Re: Property of Adam Aglietti
0 South Brook Drive Lot No. 13
Stamford, CT

Enclosed you will find a copy of the site development plan application showing revisions in response to your comments dated September 19, 2024 for the above referenced property.

Drainage Summary Report

DRAINAGE AREA MAP EXISTING CONDITIONS

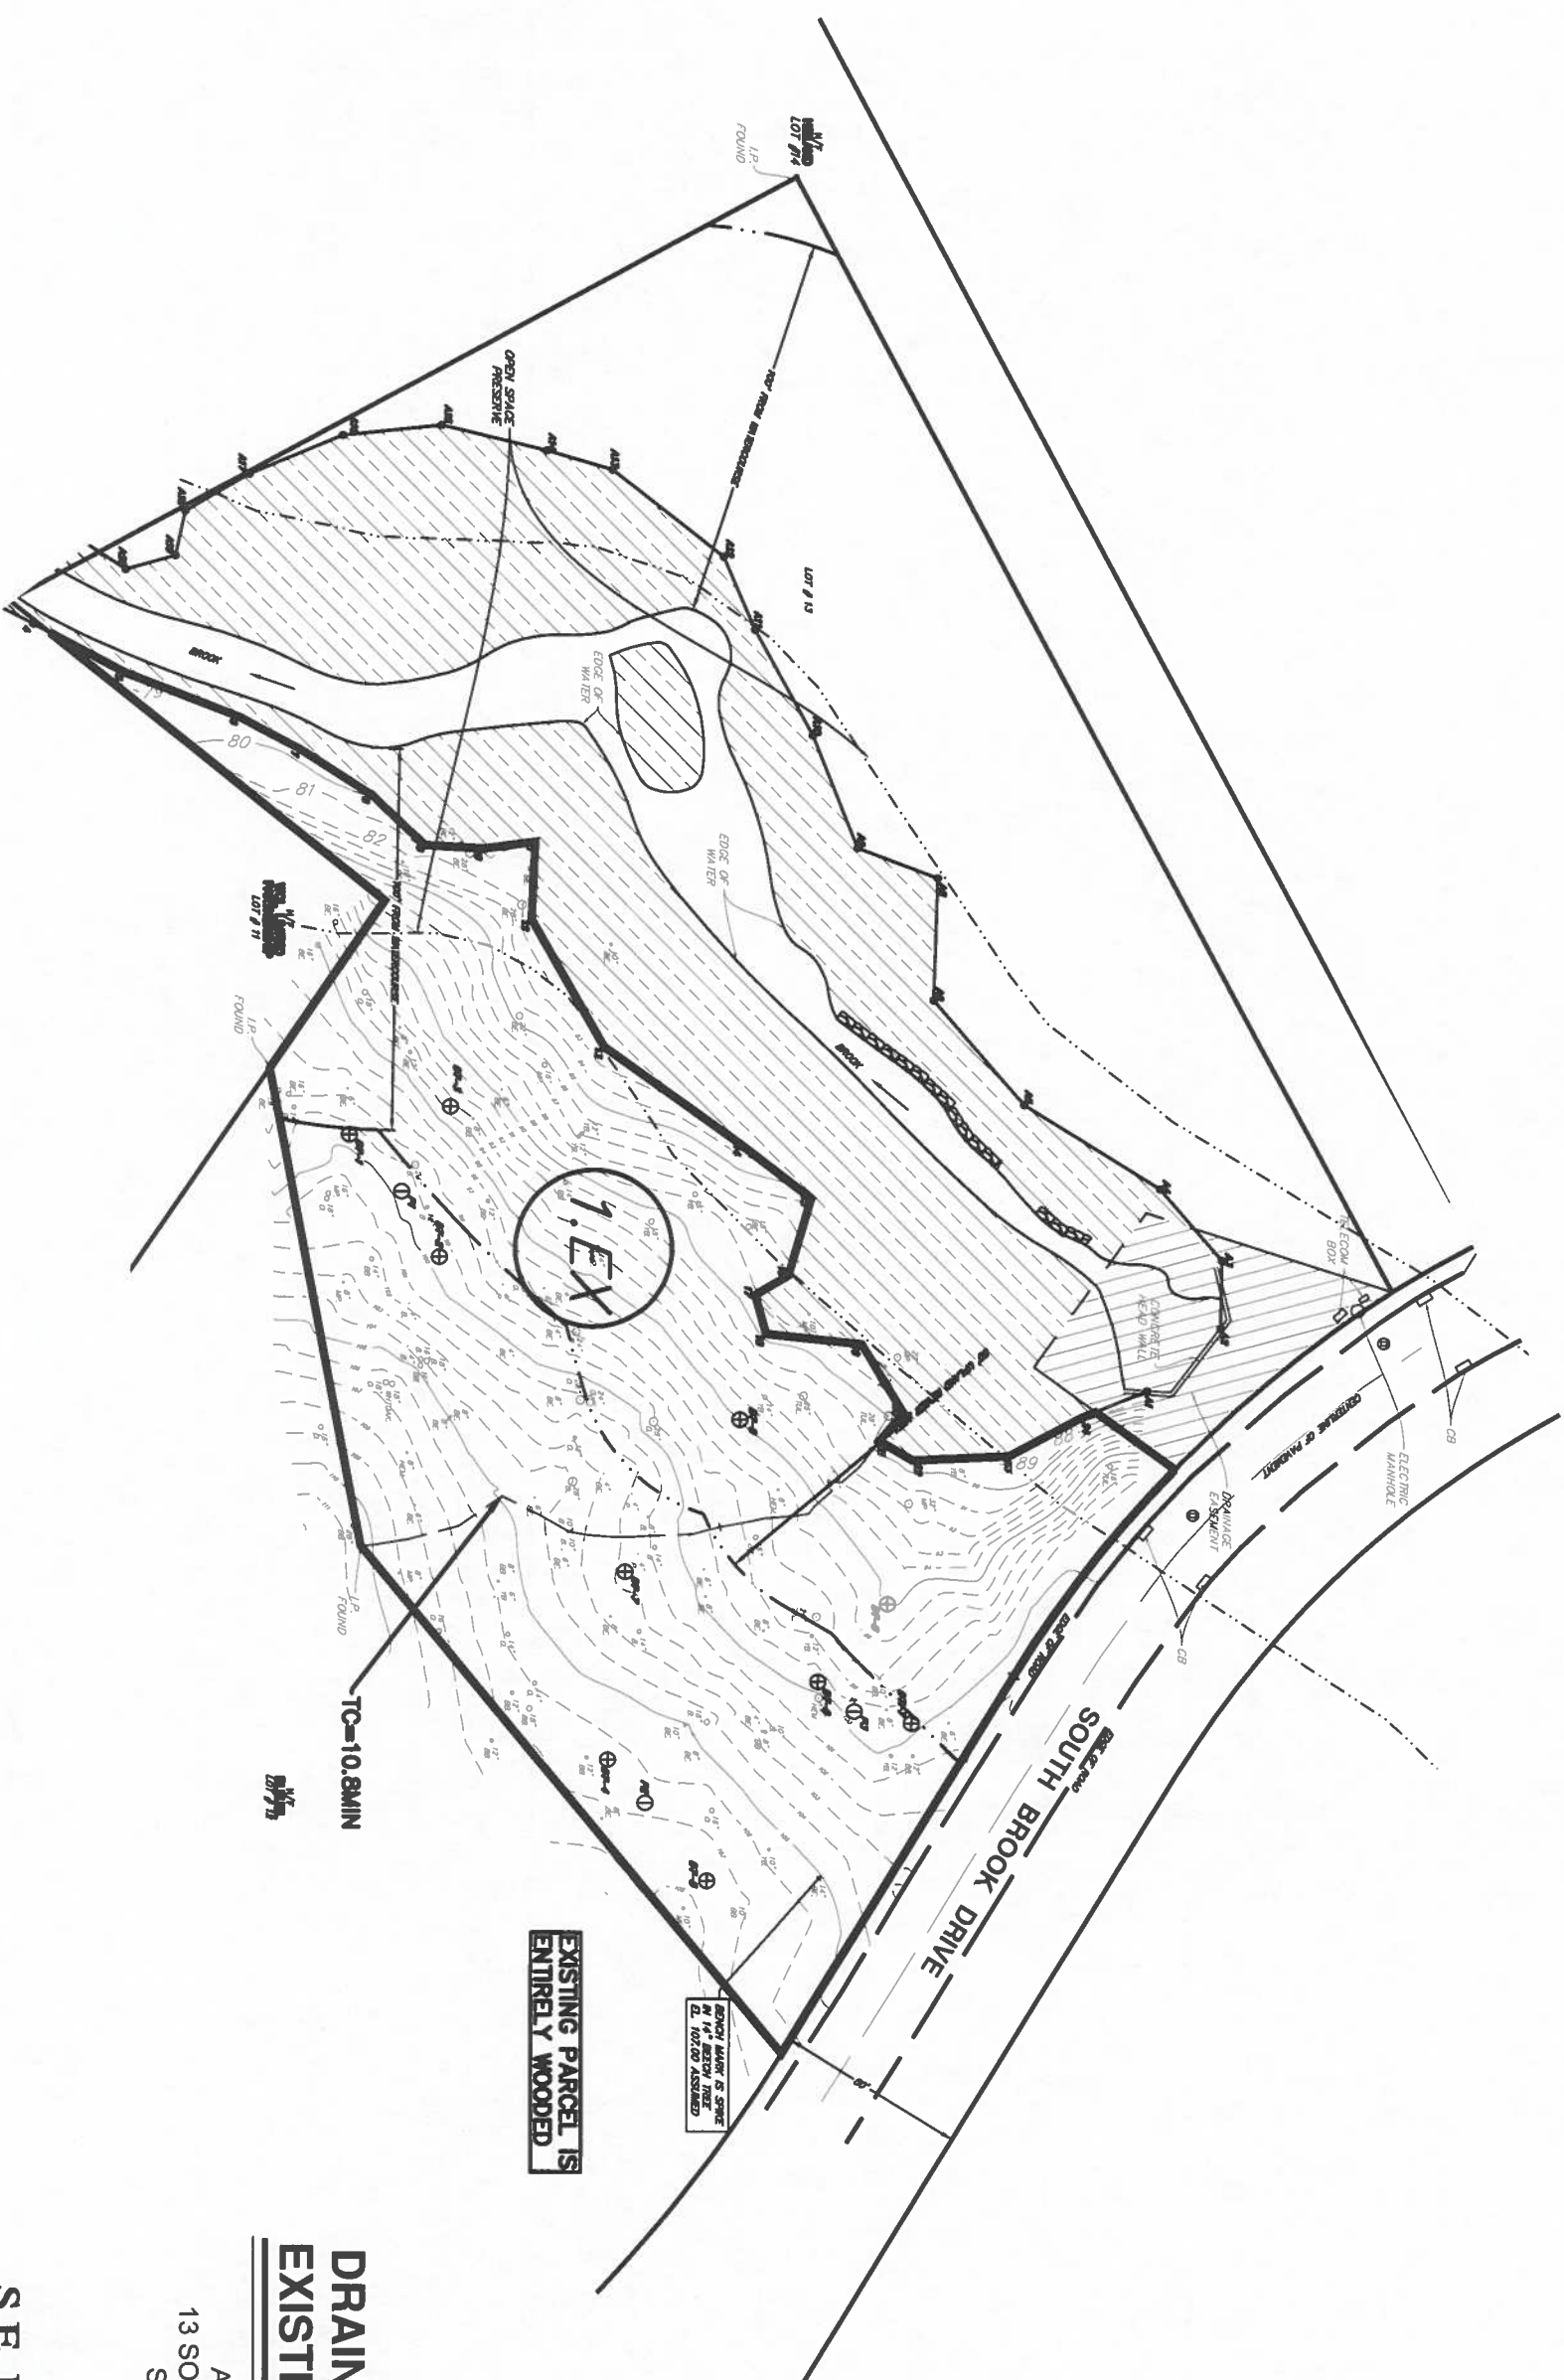
27) TC's for existing condition shall not be less than proposed. Calculate existing TC.

The TC for existing conditions is 10.8 minutes. The TC for proposed conditions is 9.7 minutes. The existing TC is longer/higher than the proposed TC.

DRAINAGE AREA MAP PROPOSED CONDITIONS

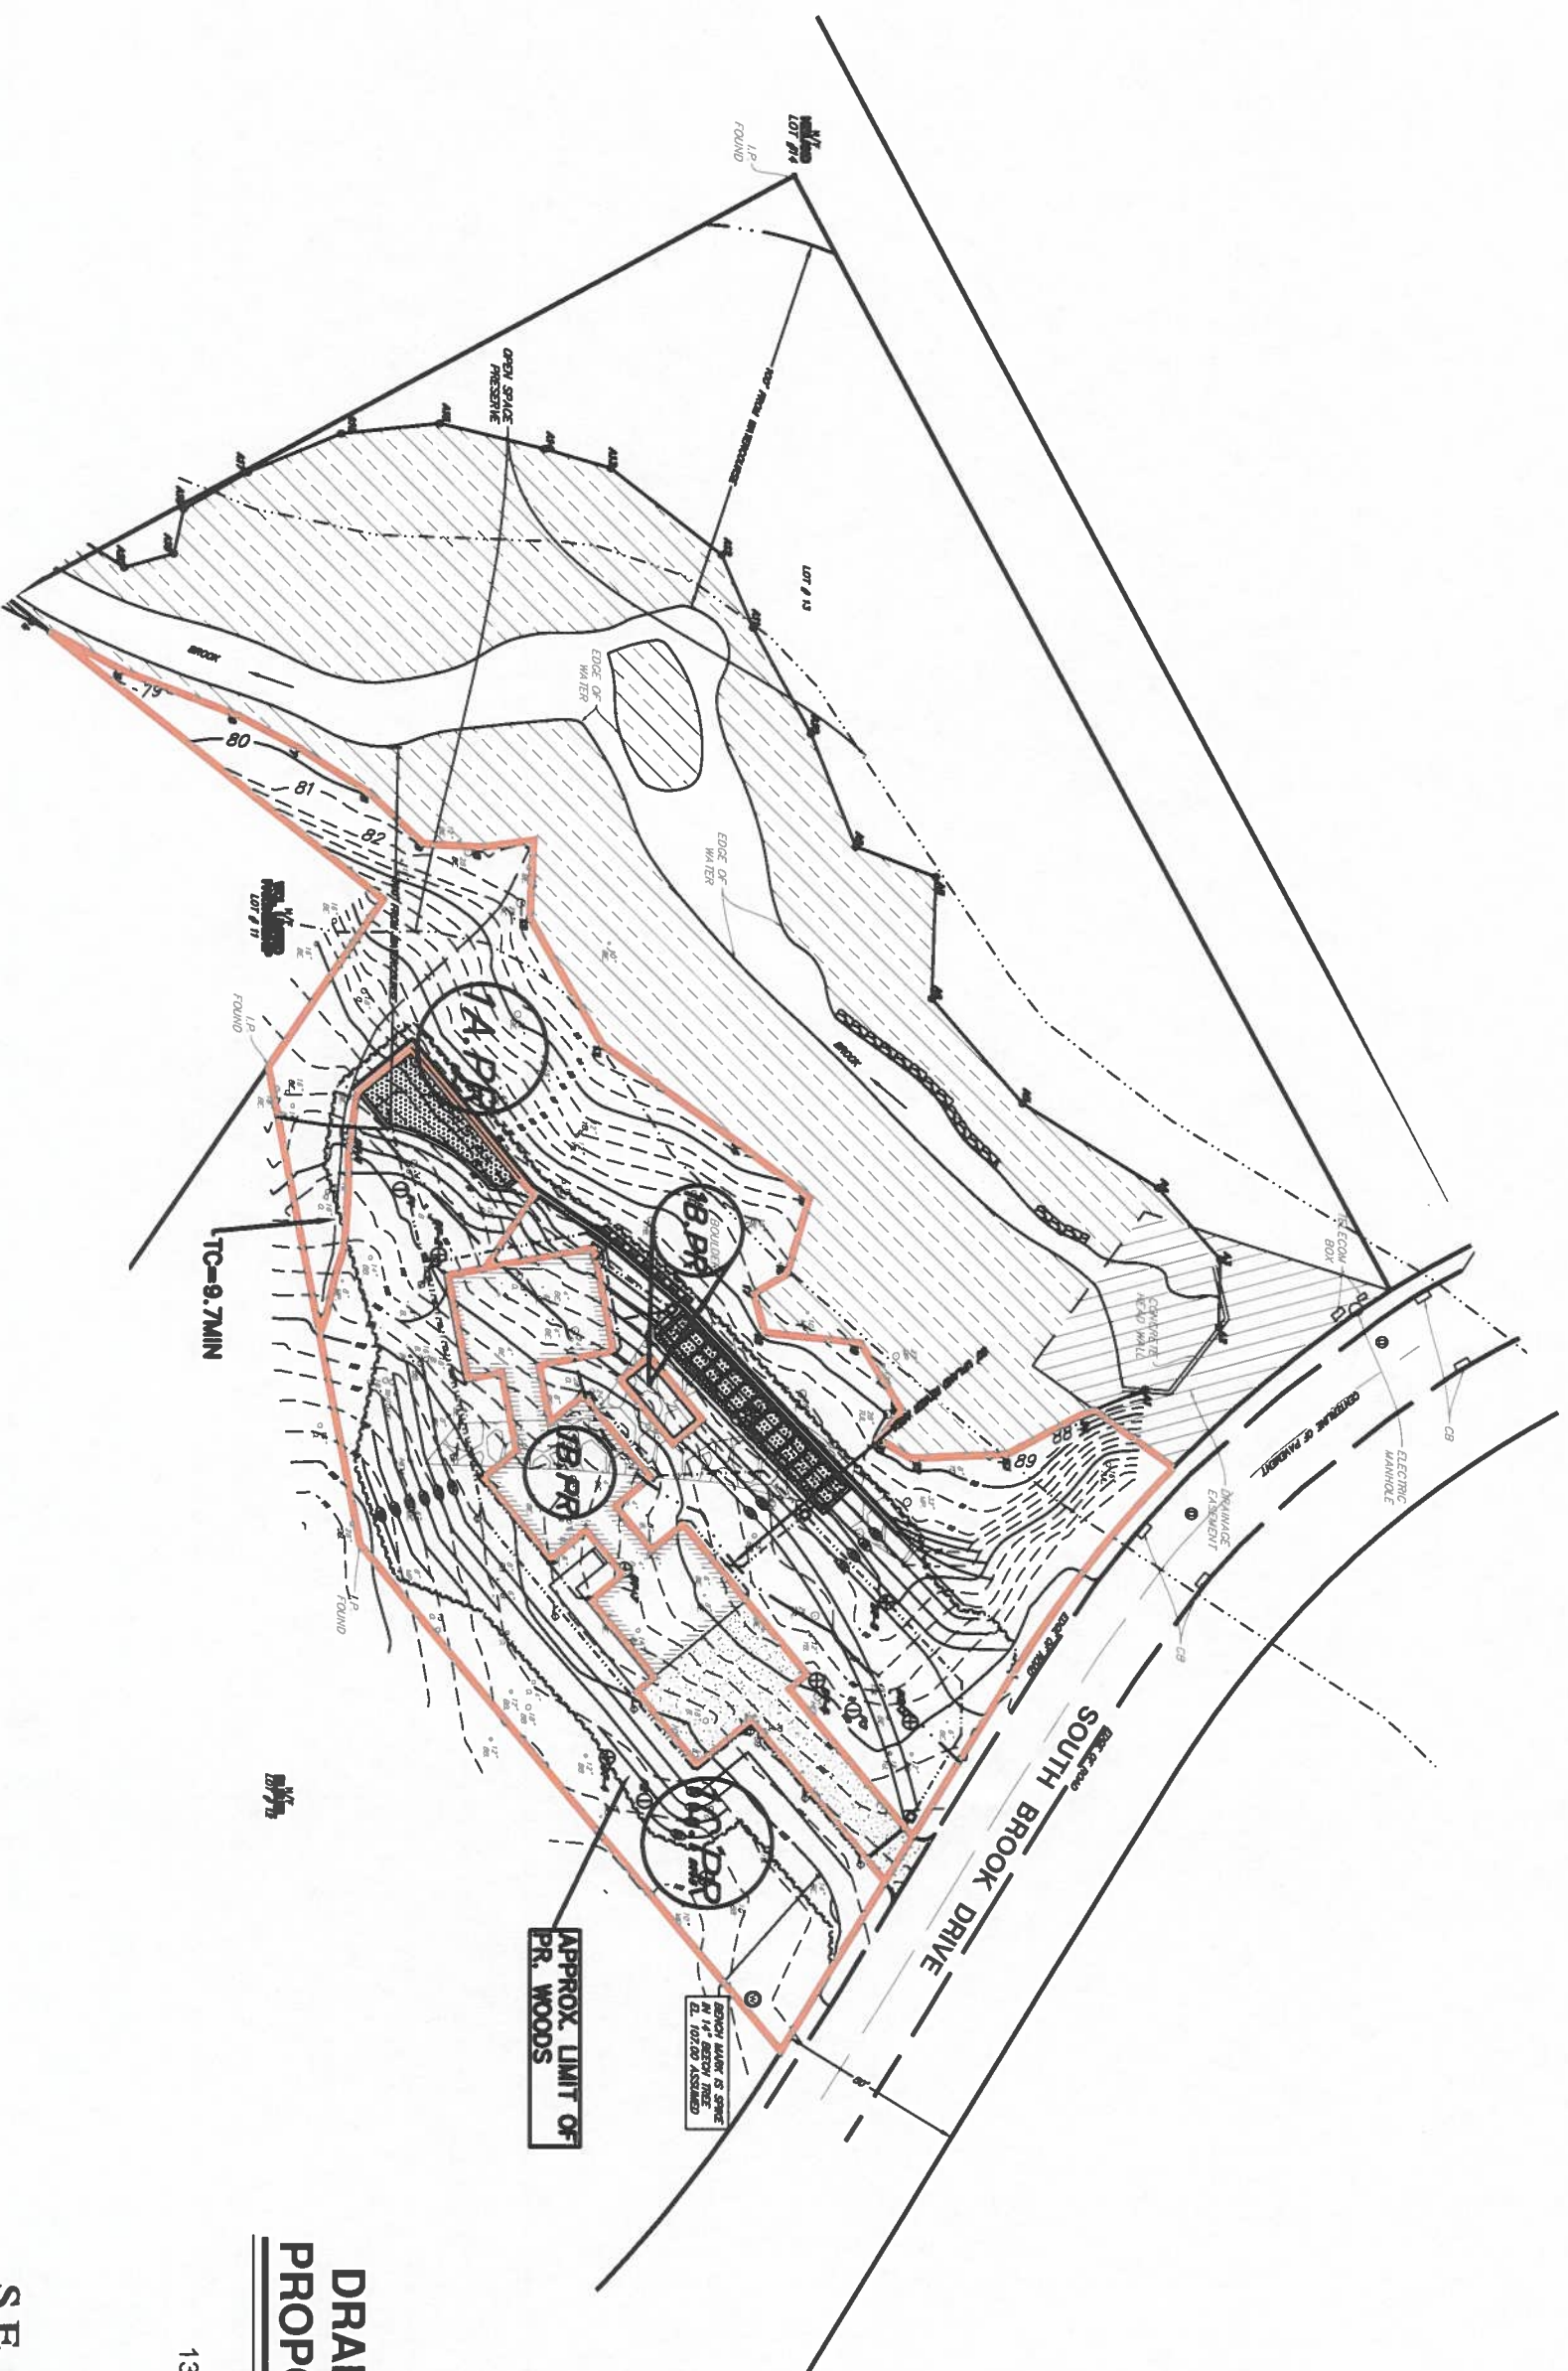
33) Clarify how the easterly portion of the roof drainage is tributary to the cultec system.

An additional roof leader manifold has been added to the front of the house to direct flow towards the cultec system in the rear.
